Platform A1 - Booth area  
Previous comments are  
still valid, see following  
slides

Platform A1 – Oven area

Axes 5-6/013-021

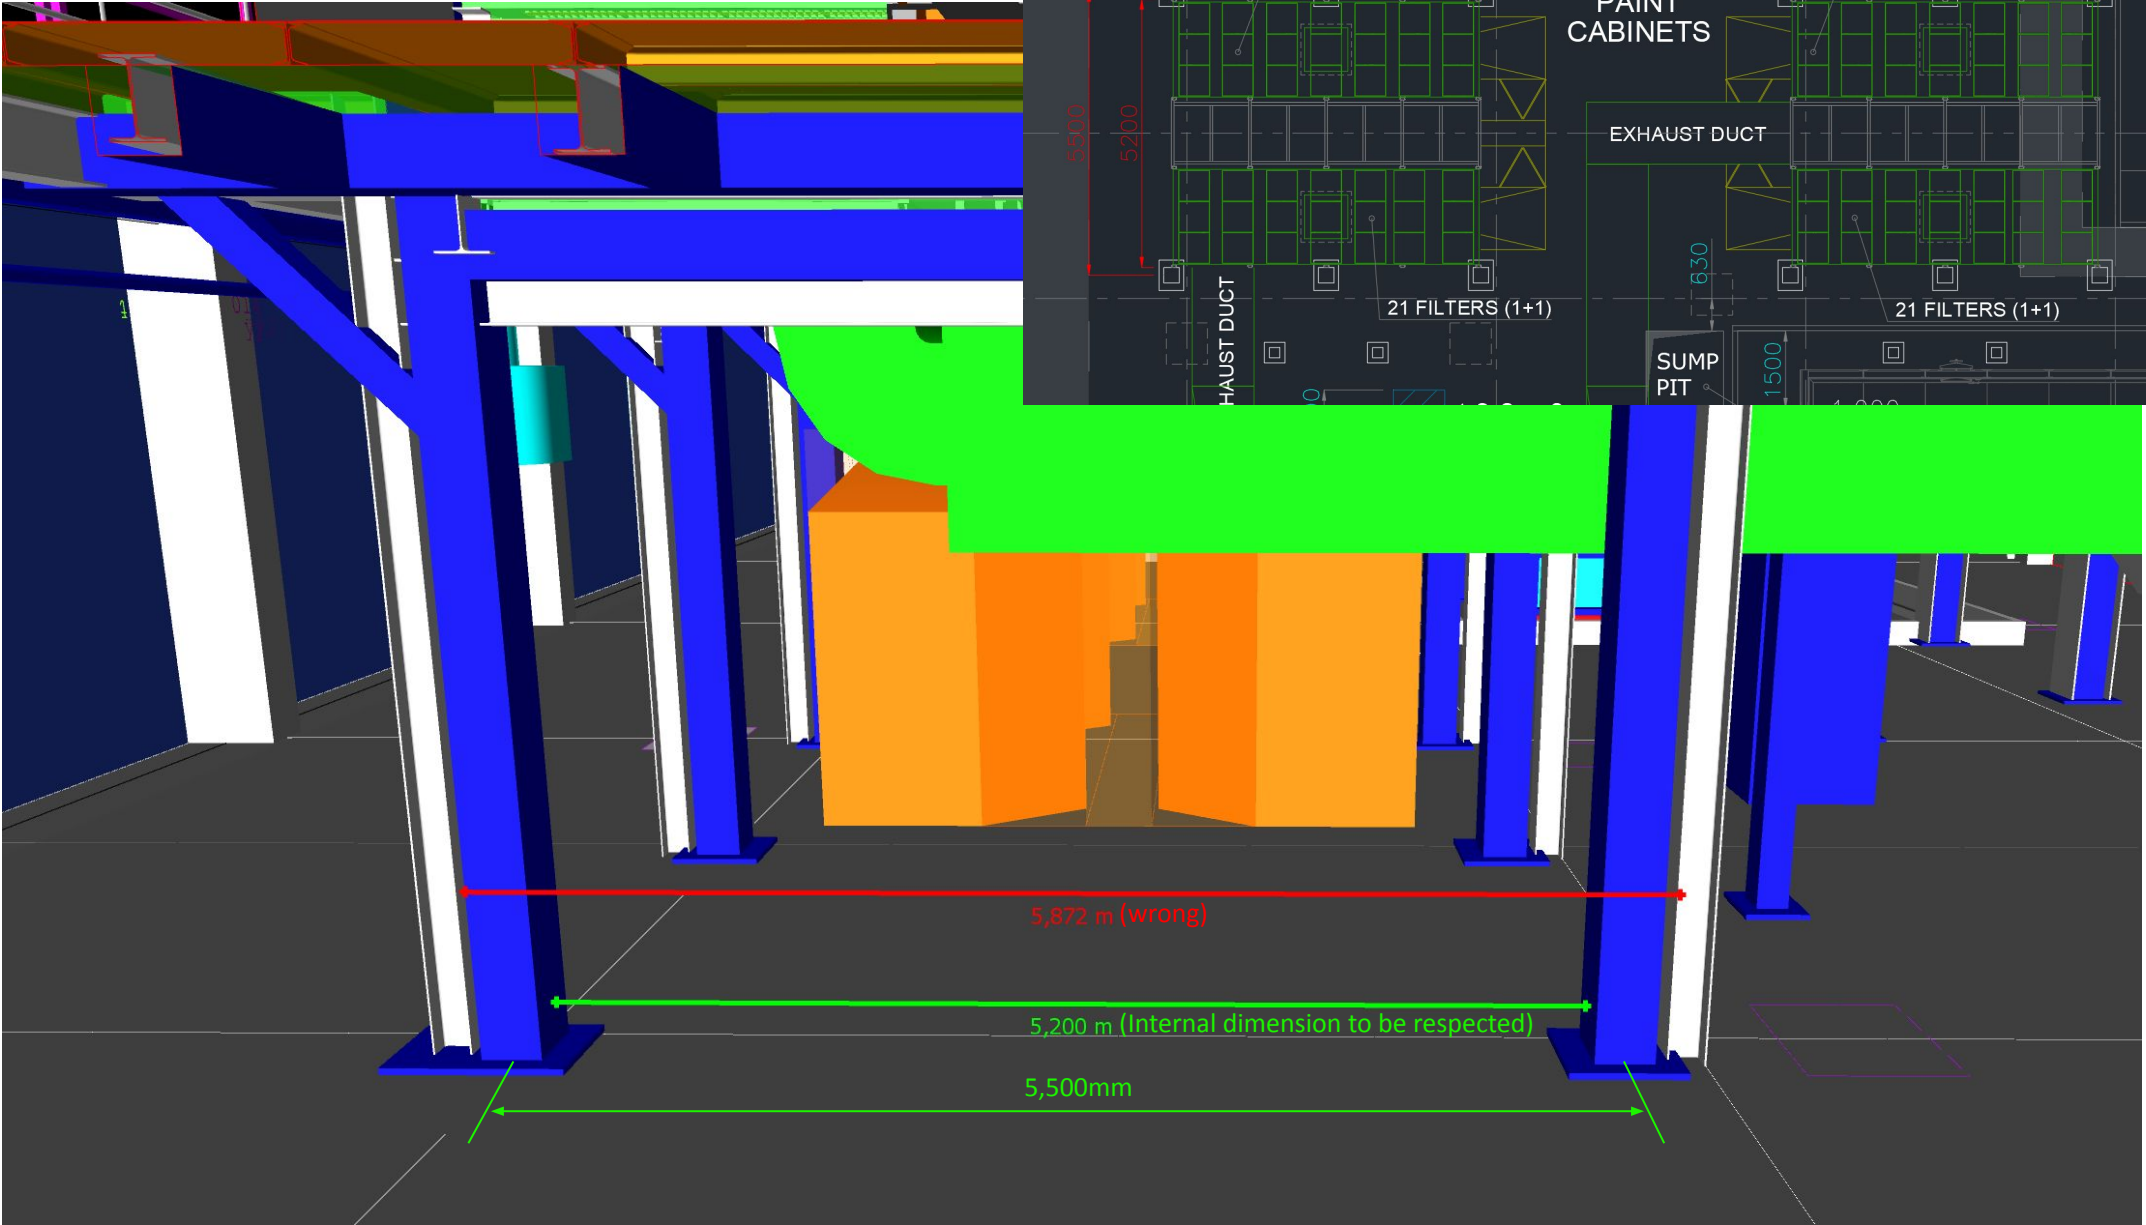
Important: the 12 columns of the Spray Booth have been modified after change of the Scrubber technology by Renault-VAZ

Axes 5-6/014-015

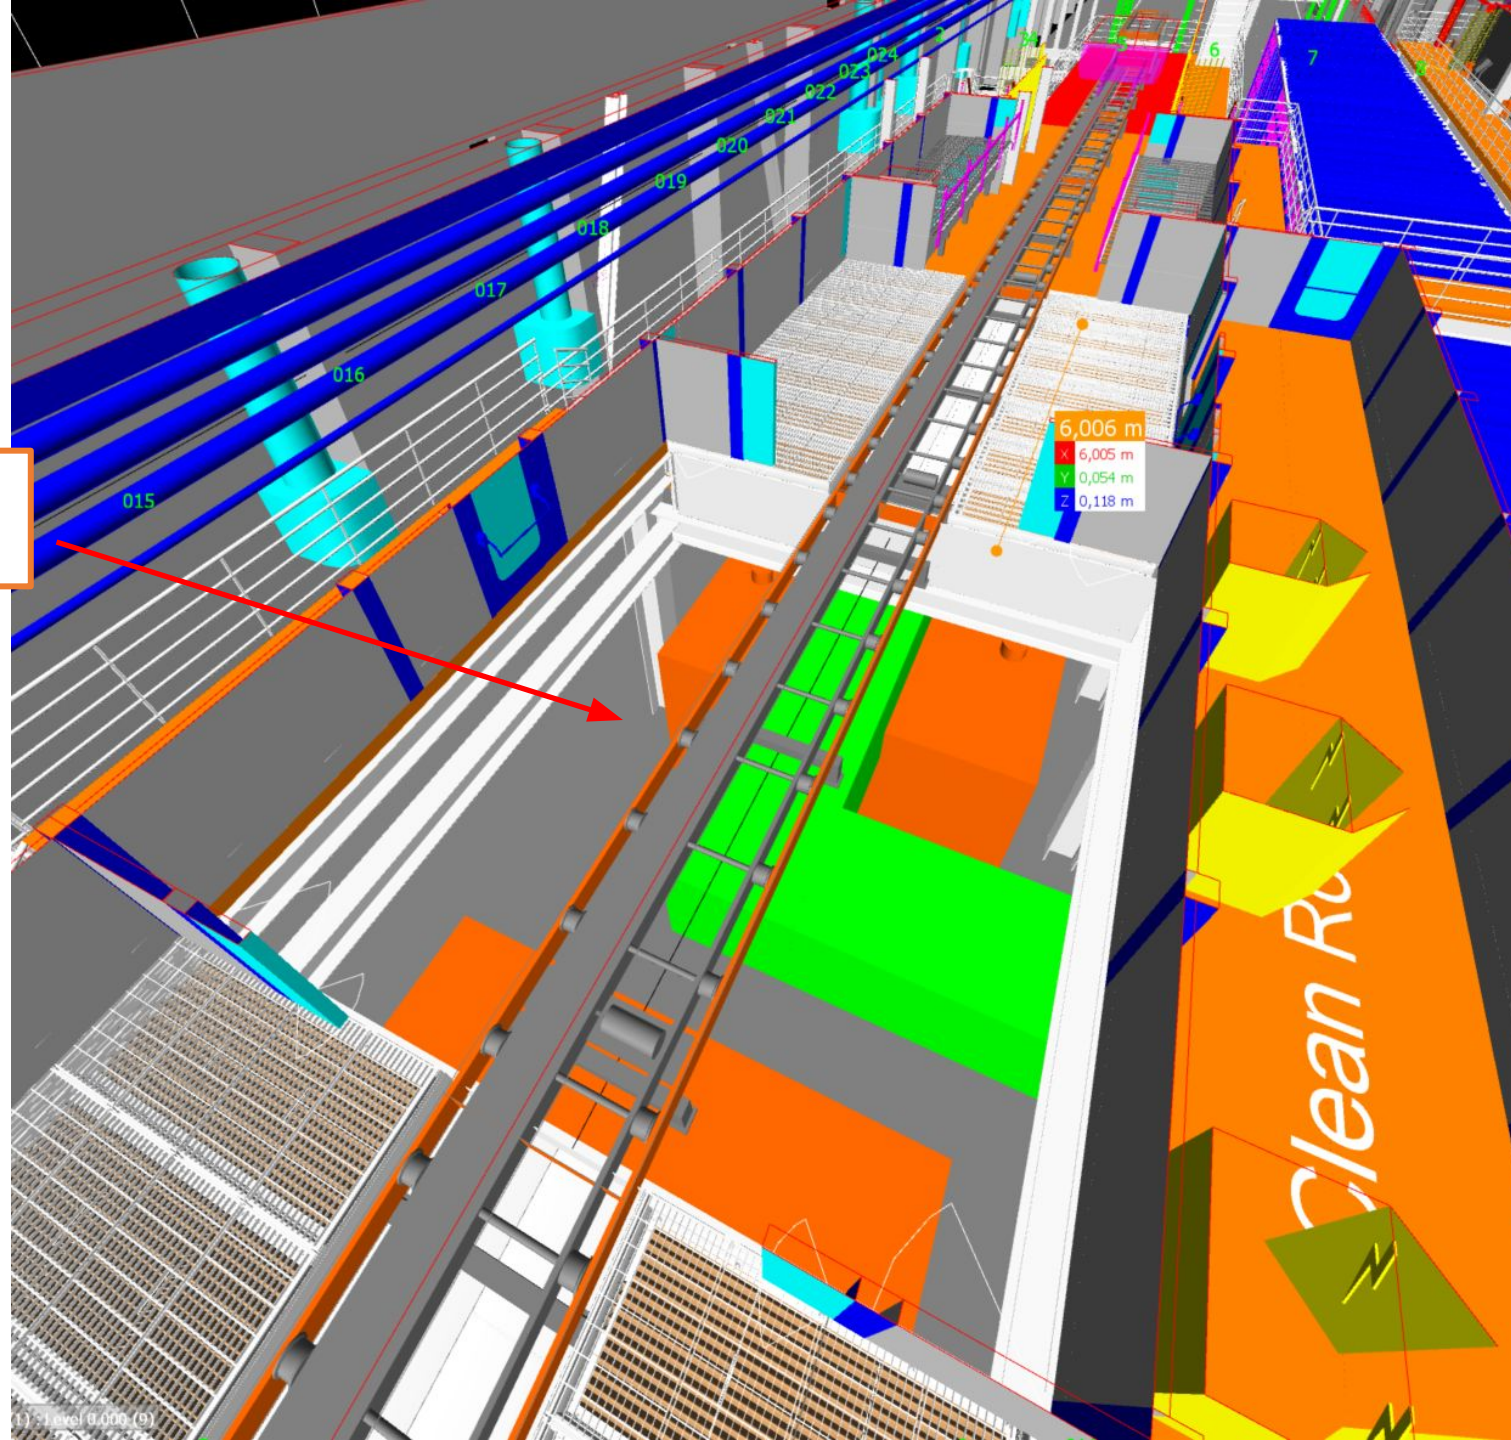
You forget the metal  
sheet and Omega Beam

Full metal sheet plate  
(t=5mm)

As you will see from our Booth layout & sections, the omega's purpose is to place the conveyor roller-bed;  
Please check correct dimensions and elevation of the Omega steel profile in section H on drawing E540350033\_D10\_A

Axes 5-6/014-015

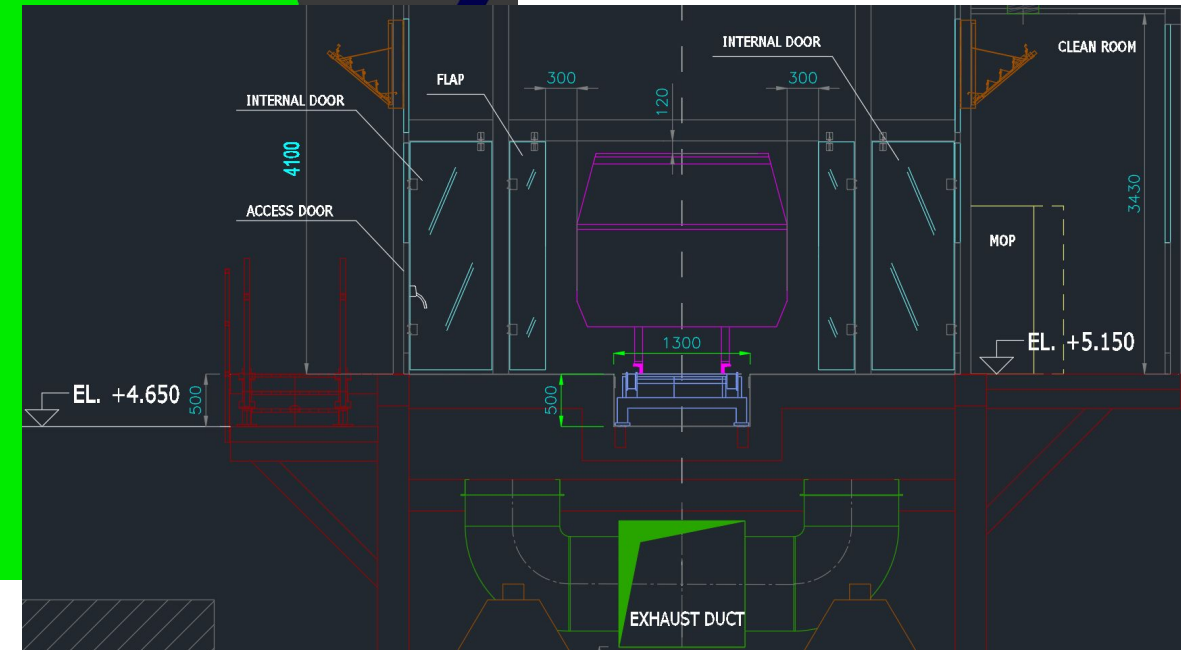
Side full metal sheet plate (non structural)  
only for gaps flashing  
(t=2÷3mm)

In Base coat and Clear coat zones we have lowered beams because we'll need to locate the **Drypan scrubber** (basically a big duct with filters) and the conveyor Roller-bed.

Axes 5-6/015-016

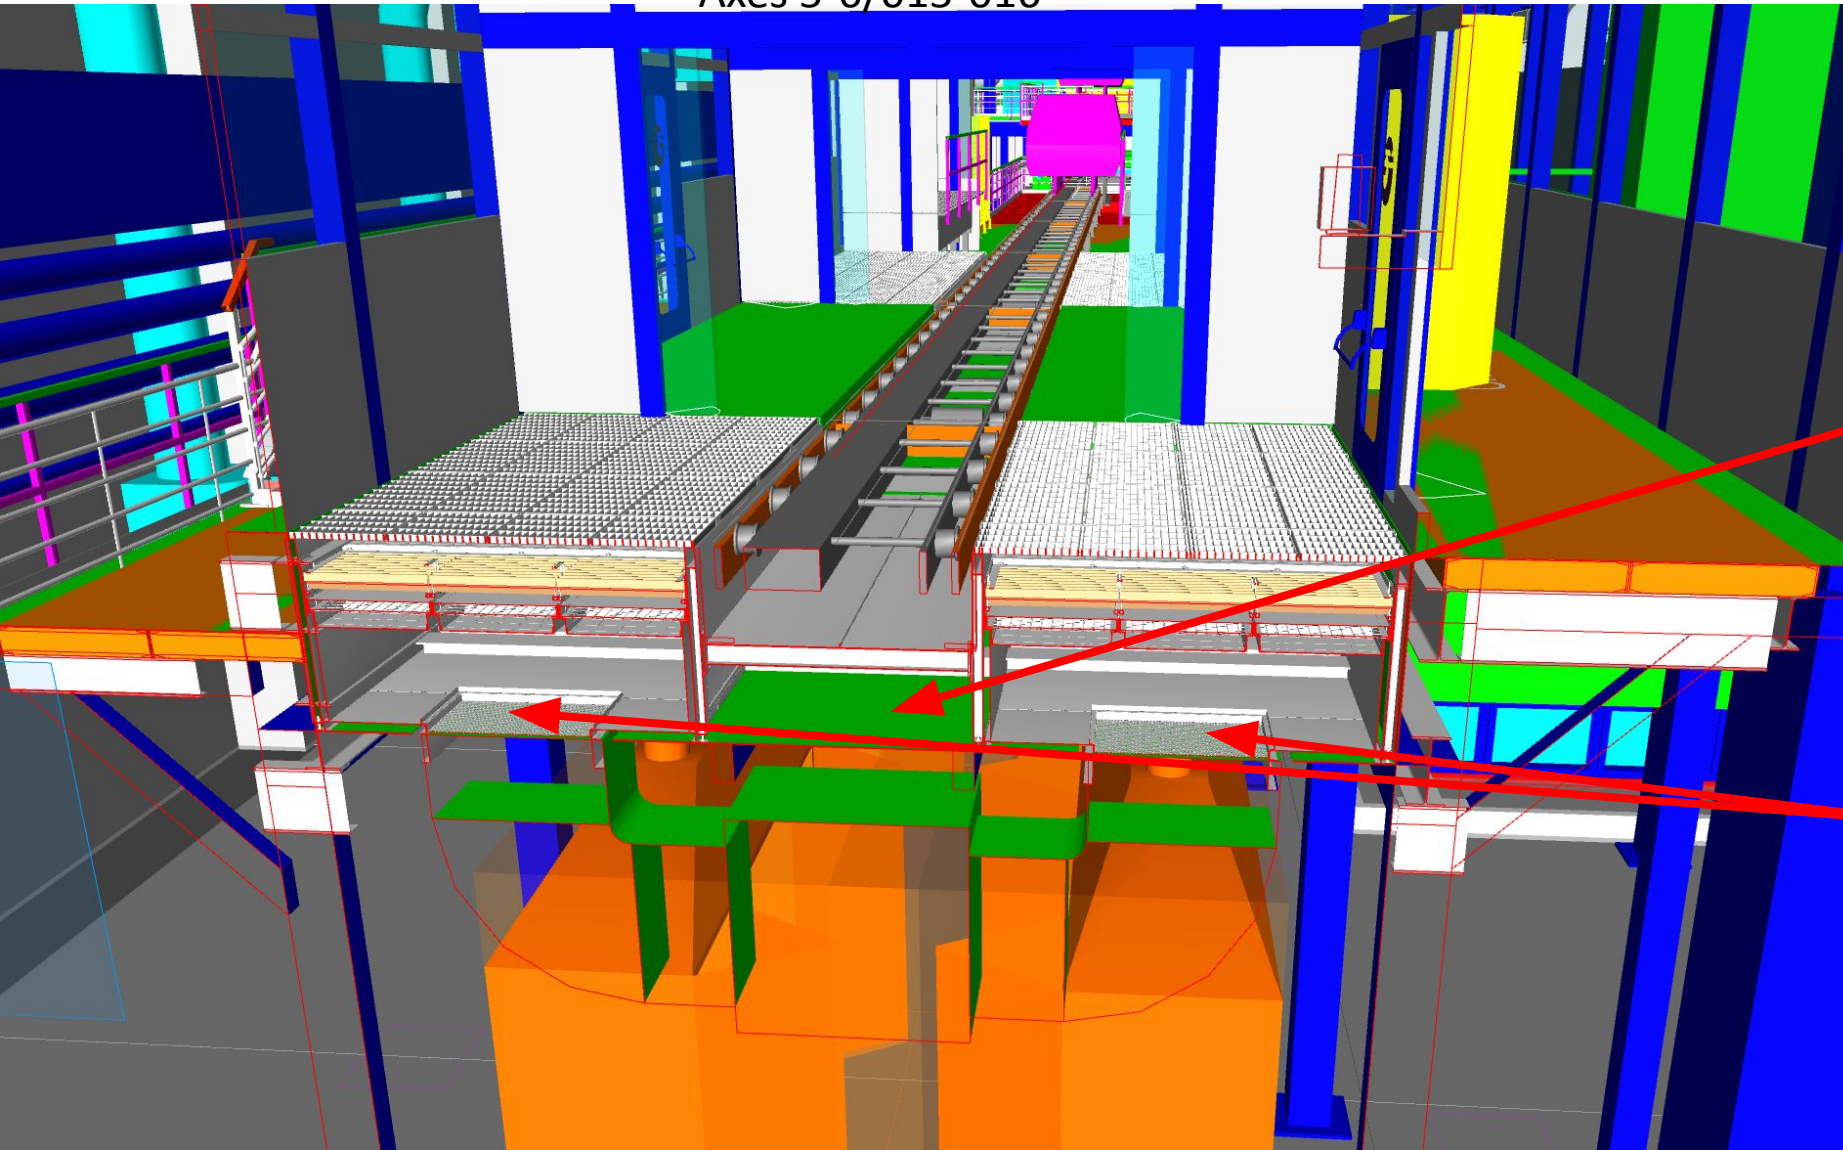
Please check our drawings (Booth layouts & sections, Drypan scrubber) for beams elevation;  
Basically in these zones the TOP of the cross beams shall be at -505mm from level 4,65m = 4,145m

The bottom of this «tank» will have to be covered by full metal sheet plate (t=5mm)

The tank floor will have to foresee two holes 950x950mm (one per side) for Extraction ducts, see layouts for location

Axes 7/013-014

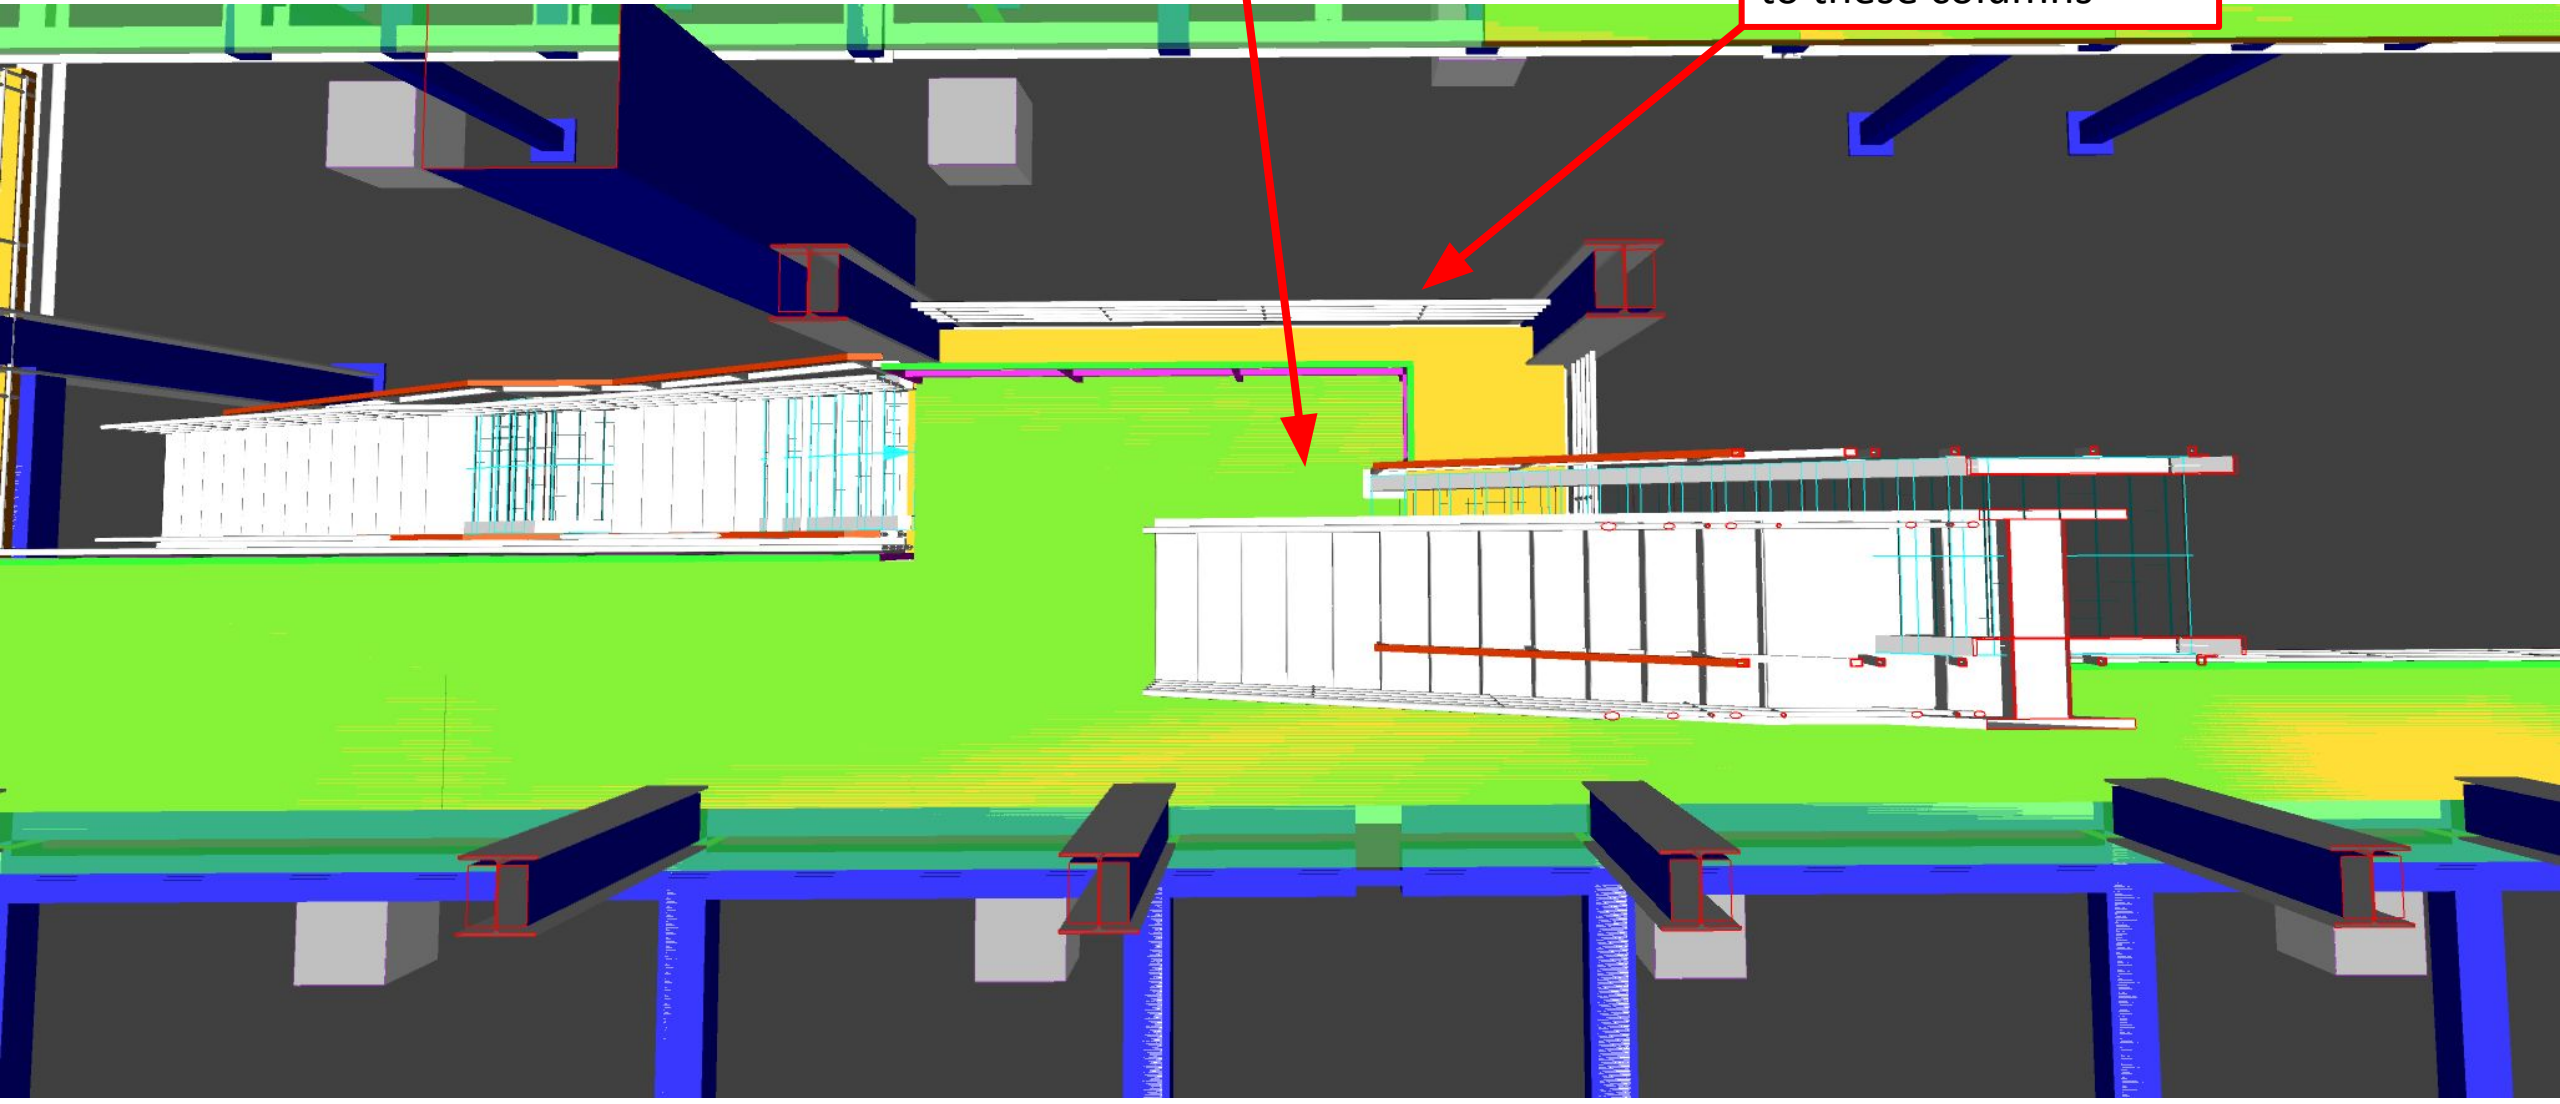
In this zone the stair that goes on 9,80m level is not aligned to ours

OK to extend platform to these columns
